State of Idaho
Department of Water Resources
Water Right License
WATER RIGHT NO. 63-34240

MEMORANDUM

SUBJECT: Licensing Review of Water Right 63-33845 and 63-34240

Flow Meter Totals - BS3200: 3X91872

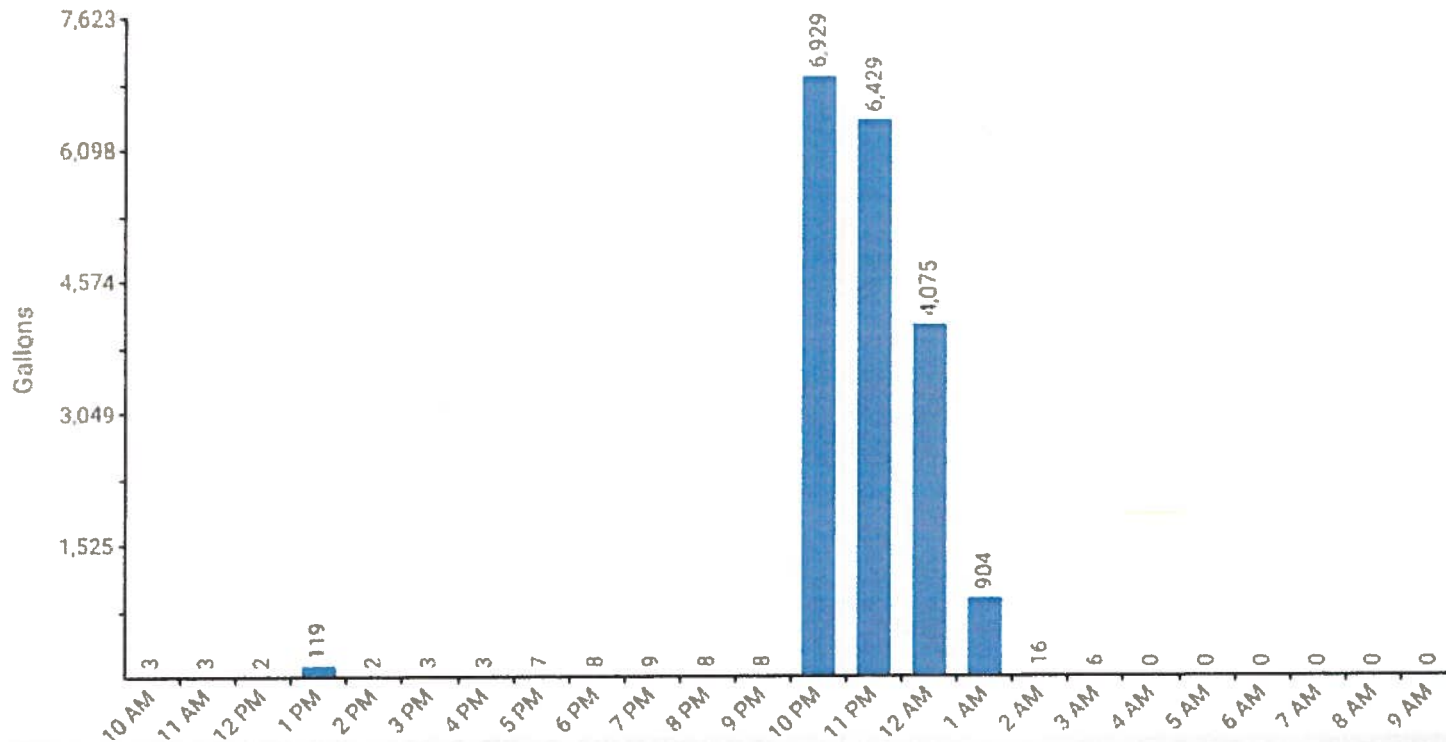
Thank you for this information. I have done a quick review of the information and I agree with you that the system was designed to operate at 140 gpm or 0.31 cfs under normal operating conditions (IMG_0131). According to your first graph (IMG_0127), it appears as though the system operates approximately 3 to 4 hours. Using the Department formula, a diversion rate of 0.31 cfs could provide adequate irrigation within a 5.1 hour period. The time of operation graph suggests that they irrigate the park in 3 to 4 hours, which fits within the parameters of the Department's formula $[(0.02 \text{ cfs/acre} \times 3.3 \text{ acres}) / (5.1 \text{ Hours} / 24 \text{ Hours}) = 0.31 \text{ cfs}]$. I also believe that the system application time per set is probably increased during warmer drier seasons.

- The first image (IMG_0127.PNG) shows the hourly volume of irrigation water applied. For example, from 10 pm to 11 pm, it looks like the system used 6929 gallons (115 gpm average).
- The second, third, and fourth images (IMG_0128.PNG, IMG_0129.PNG, IMG_0130.PNG) show the programs. It looks like this park has 17 sprinkler zones ranging in demands from 1.9 gpm to 69.7 gpm.
